Case #BZA23-000020
Kiawah Island BZA Meeting of January 22, 2024

Property Location: 179 Marsh Hawk Lane

Request: Variance request for the reduction of the required 30' rear setback for approximately 150 square feet for a proposed screened porch enclosure.

Staff Review:

NEW SITE PLAN
SCALE: 1/8" = 1'-0"

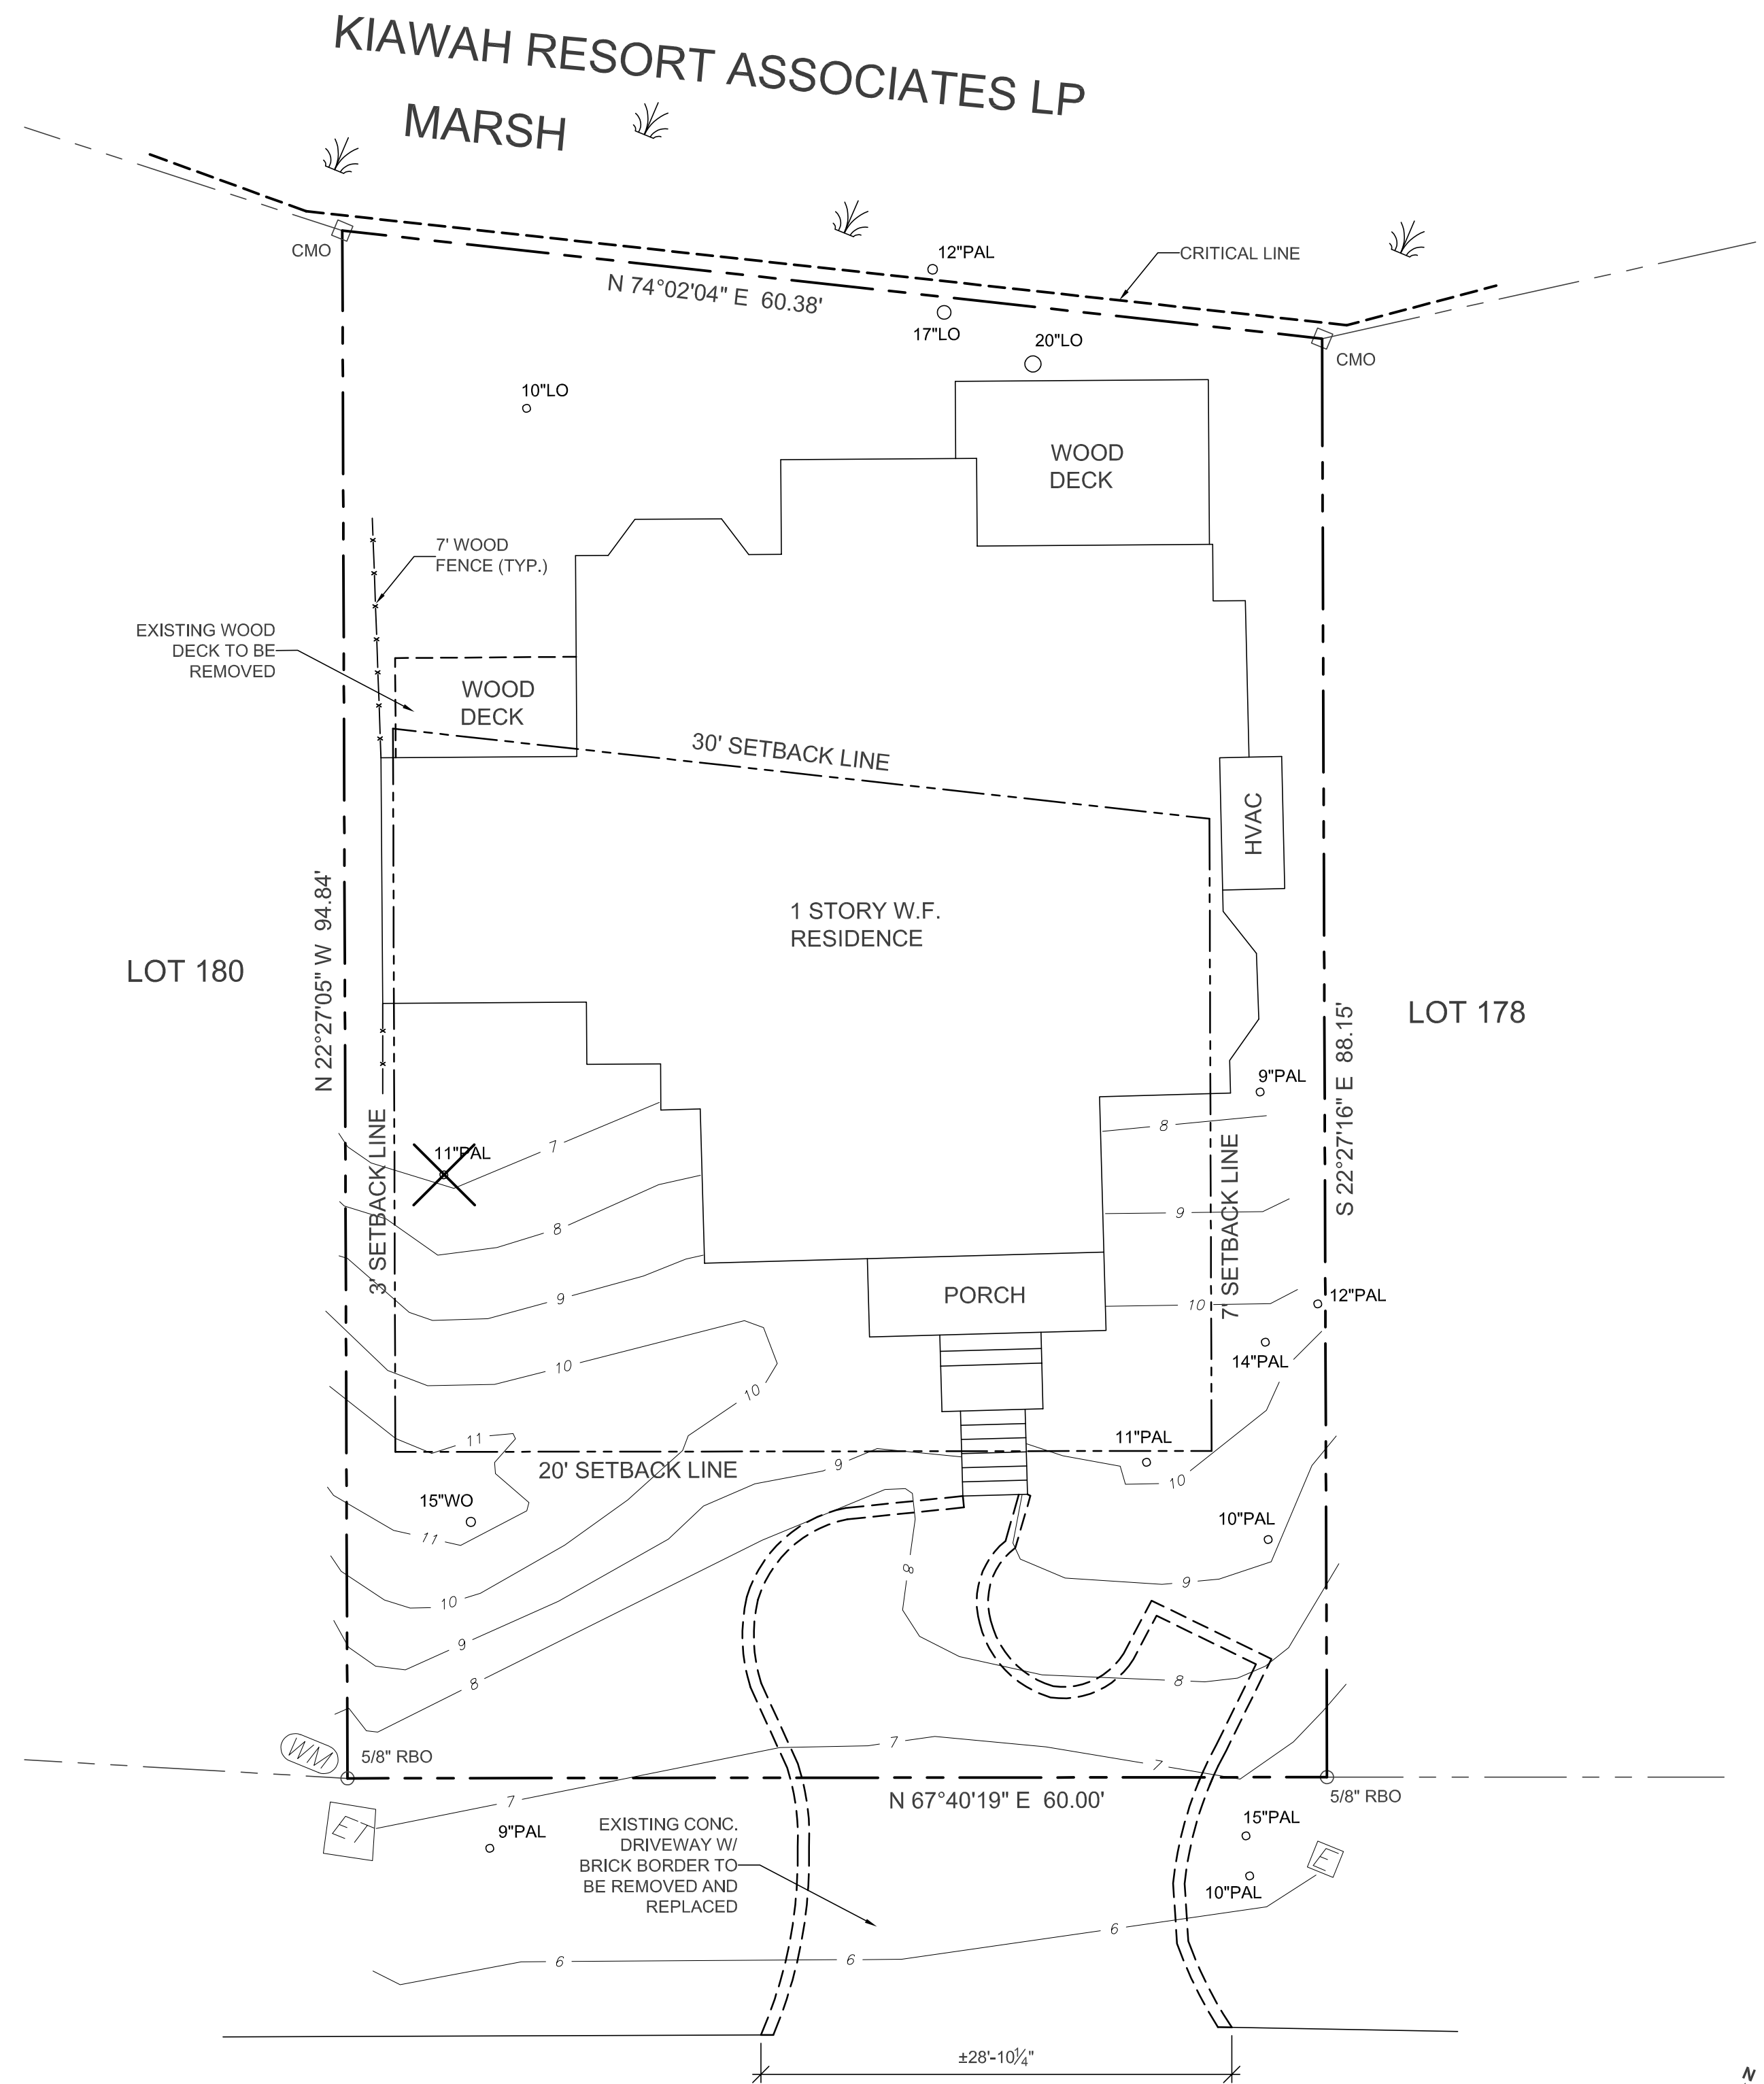
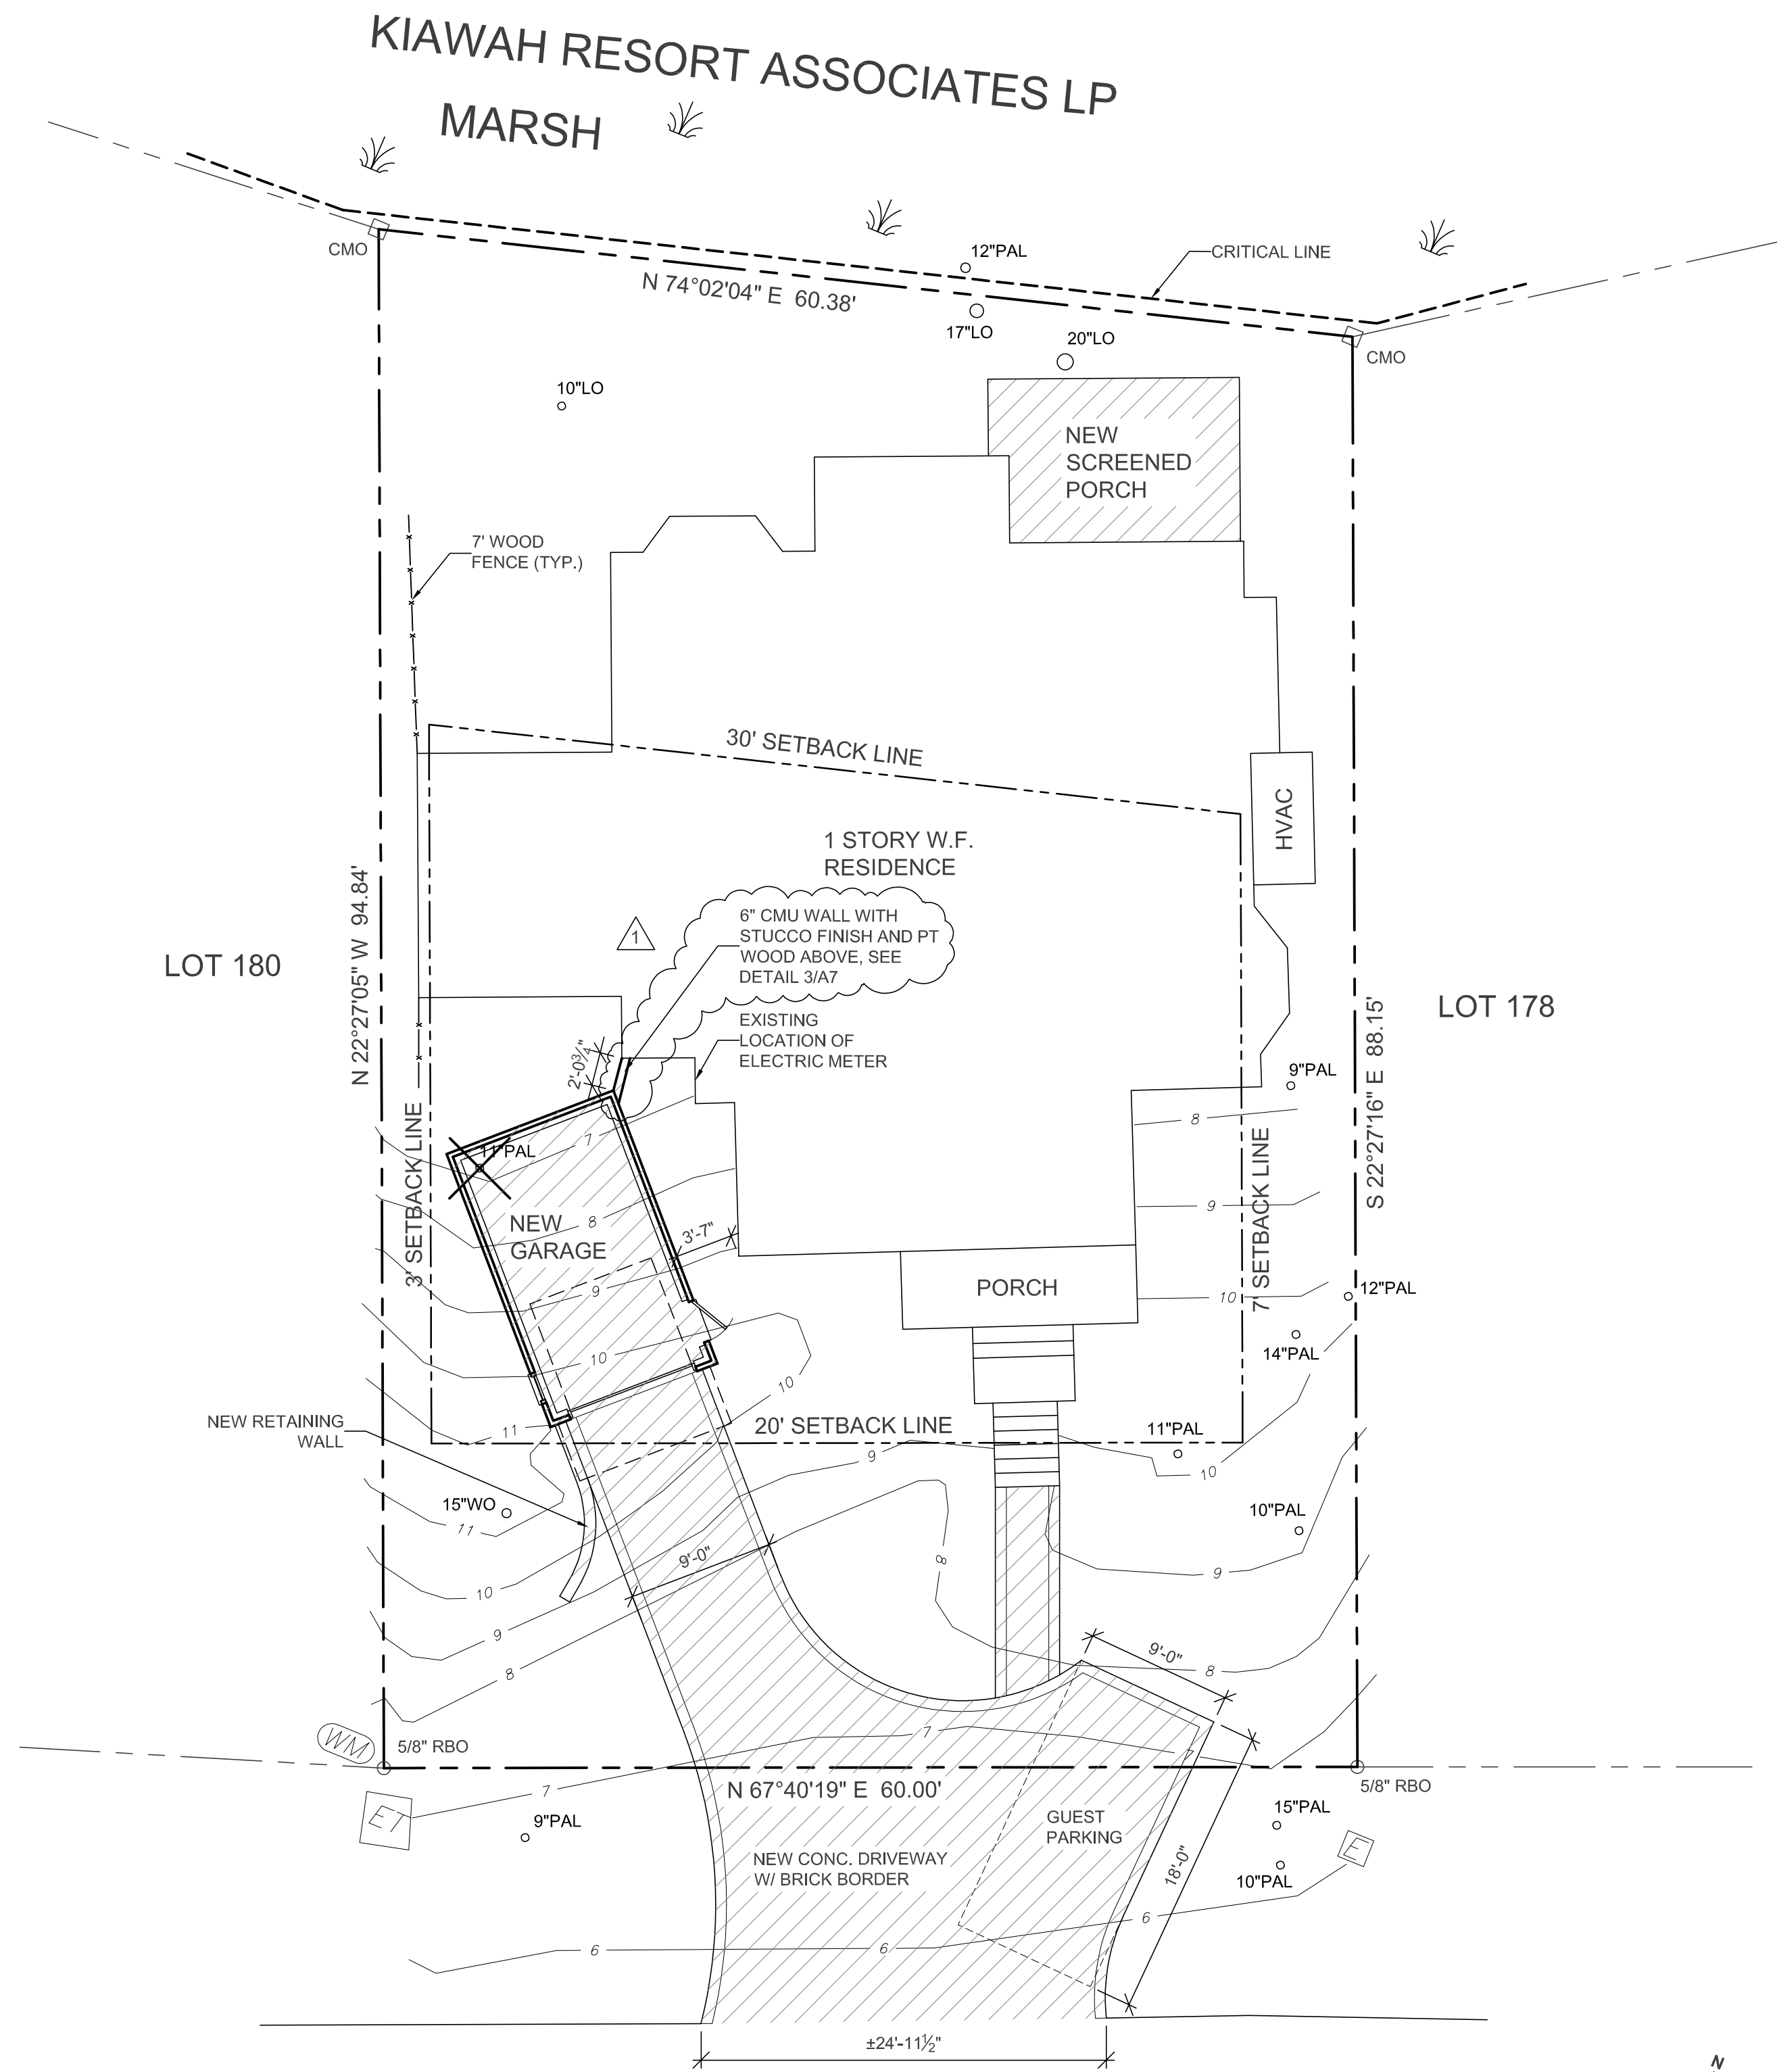
The applicant’s proposed plans include converting an existing open deck on the north east side of the property to a screen porch and the removal of the existing open deck on the northwest corner of the home. The current structure including the existing deck on the northeast corner of the home which is approximately 150 square feet is legally conforming with regards to the setbacks. The proposed screen in porch would encroach the rear setback by approximately 150 square feet. The lot coverage percentage for the property will not change.

Staff Response: **The application of this Ordinance to 179 Marsh Hawk Lane would prohibit the conversion of the proposed screened in porch as the proposed structure encroaches into the required 30' foot rear setback. However, it does not unreasonably restrict the utilization of the property.**

Staff Response: **The authorization of this variance may not be of substantial detriment to the adjacent properties or the public good. The proposed porch addition suggests an encroachment of 150 square feet in converting the from the existing deck. The footprint of the home will not be changed by the granting of this variance. Per the applicant's letter of intent, "We are not proposing to alter the footprint of the existing deck in any way,**

- 1. Provide detailed plan to ensure the existing 20" live oak adjacent to the deck is not damaged during construction of the screen porch.**
